INITIAL FIRE SAFETY INSPECTION REPORT

Modele De Capital Ind. Ltd. (Unit 2)

Date: 27 June-2022

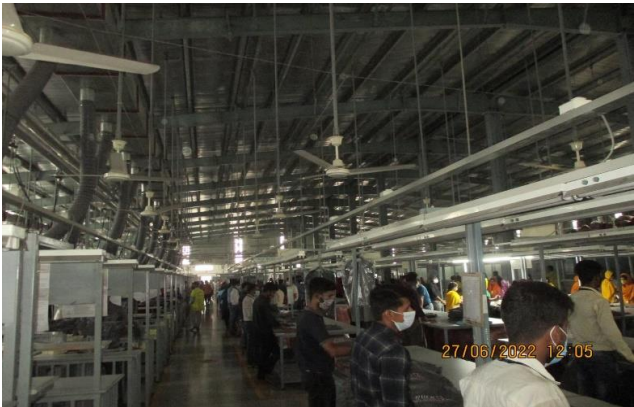
Table-1:				
SI No.	Category	Findings	Required Action	Remediation Time Frame
F-01	Fire Rated Construction	Transformer, generator, boilers, and compressor room are not properly separated from each others by fire rated construction. Location: Utility Shed-3.	Separate the transformer, generator, boiler, and compressor room by a minimum 2-hr fire rated constructions. Seal and/or protect all opening to maintain the required fire separation. Provide proper ventilation system with consult a qualified engineer. Follow the RSC Technical Guidelines (Standard)-3.4.2.1	Within 3 months
